Re: Minor Alteration to Development Approval  
Approval No: 17861/2021/PDA  
Proposal: § Reconfiguration of a Lot (1 into 152 lots, one (1) balance lot, new road, open space and park in stages), and  
§ Material Change of Use - Plan of Development (POD) (6 dwelling types)  
Property Location: 7000 Binnies Road, RIPLEY QLD 4306

I refer to your correspondence dated 7 March 2023 (with fees paid on 15 March 2023) requesting minor alteration to Condition 4 'Conditions to be met prior to commencement of development' of Attachment A and approved plans associated with the abovementioned development permit, in accordance with Condition 2 'Minor Alterations'. Specifically, you have requested the below changes:

PLAN OF DEVELOPMENT: STAGES 9, 10 & 13  
LAYOUT PLAN  
SATTERLEY PROPERTY GROUP PTY LTD  
459-489 RIPLEY ROAD, RIPLEY

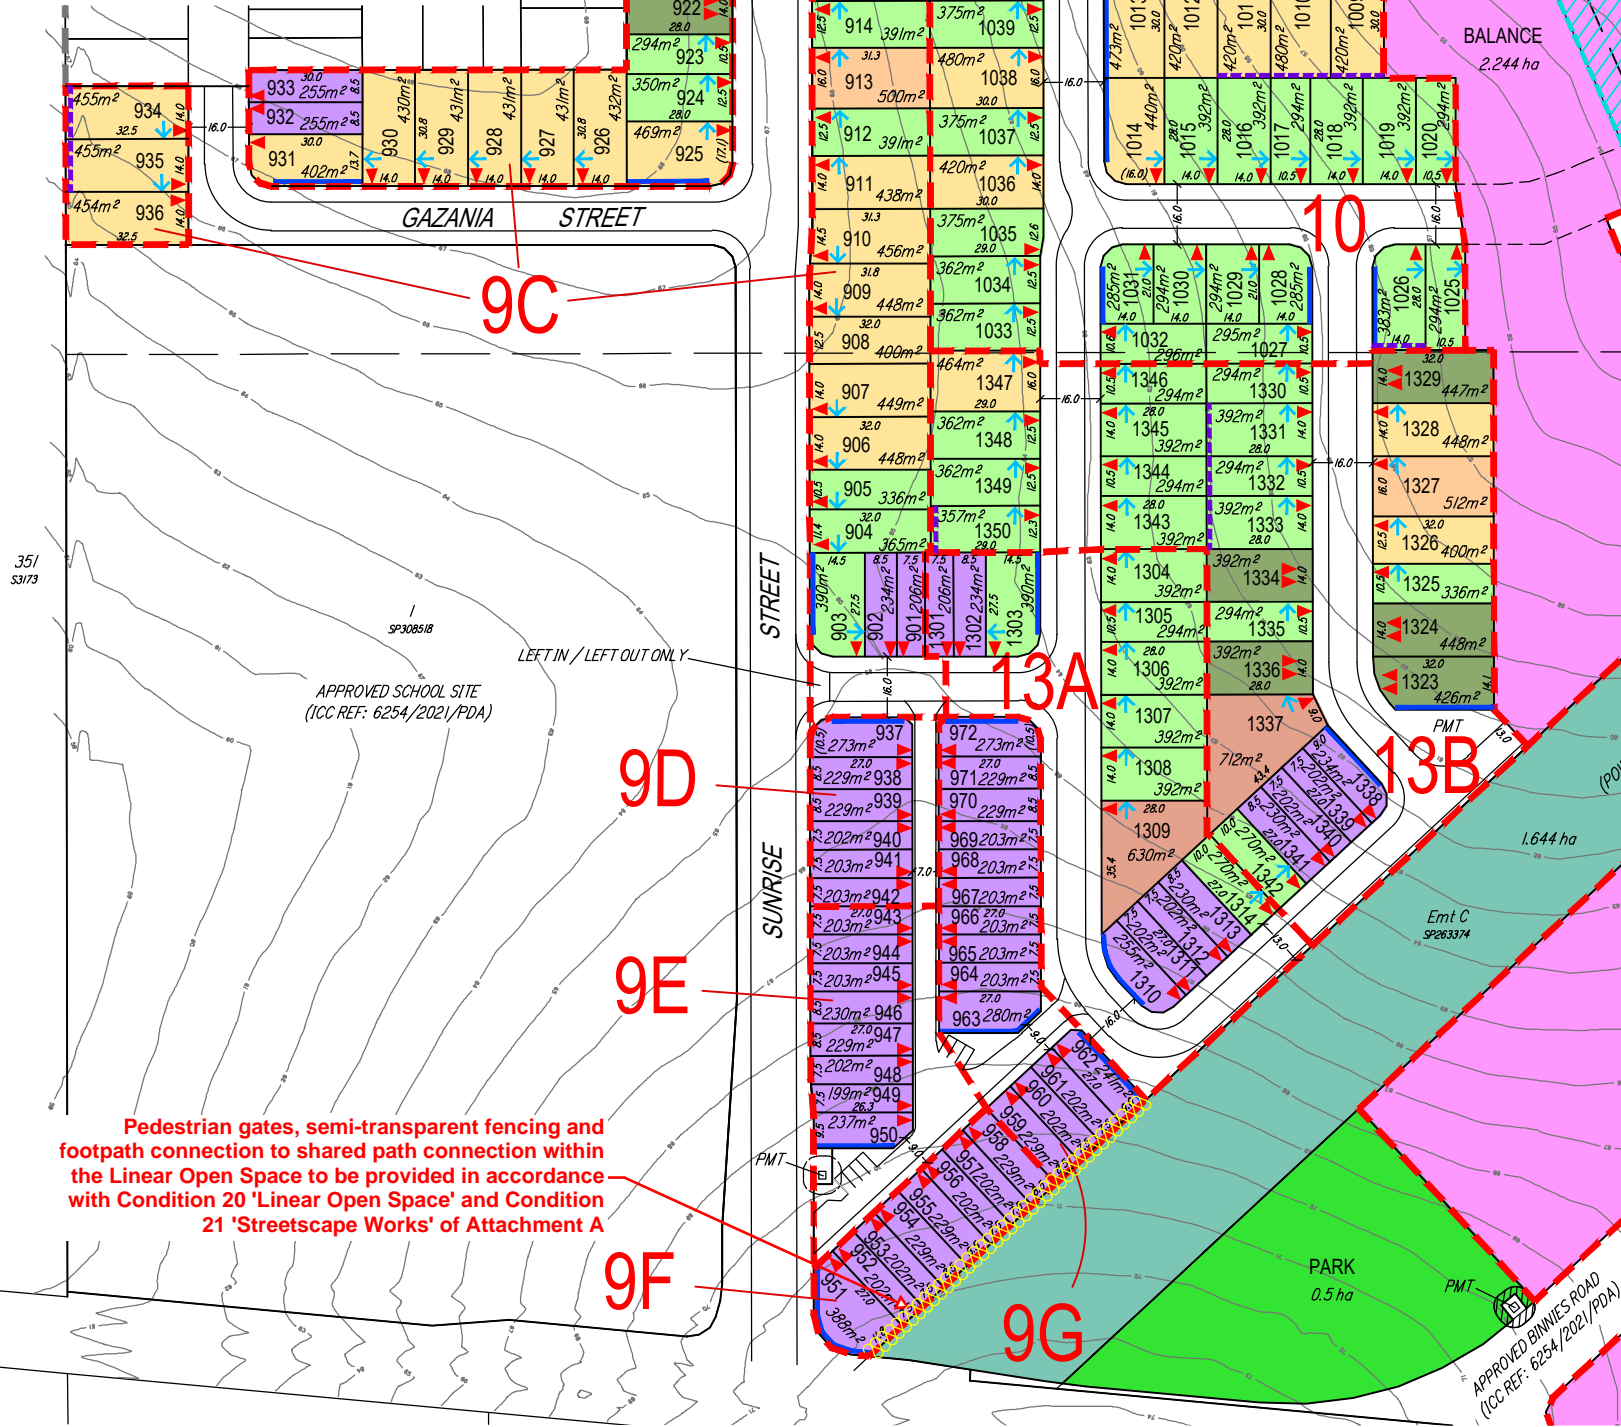
- reinstatement of Neighbourhood Recreation Park area (minimum 5,000m<sup>2</sup> in land area) within the subject development site and clarification of the timing to be consistent with Condition 5(d) and Conditions 19(a) & 19(b) of Attachment A; and

- incorporate an additional PMT site on the south-eastern side of the Neighbourhood Recreation Park.

ISSUES:	DATE:	INIT:
V	PARK & PMT ADDED	07-03-23 TJM
U	STAGE 9C SUBSTAGING	02-12-22 TJM
T	STAGE 9 PAVEMENT UPDATED	15-11-22 TJM
S	STAGE 9 LANEWAY WIDENED	08-09-22 TJM
R	STAGE 9 LANEWAY WIDENED	07-09-22 TJM
A	ORIGINAL	31-05-21 TJM
ISSUE:	DETAILS:	DATE:
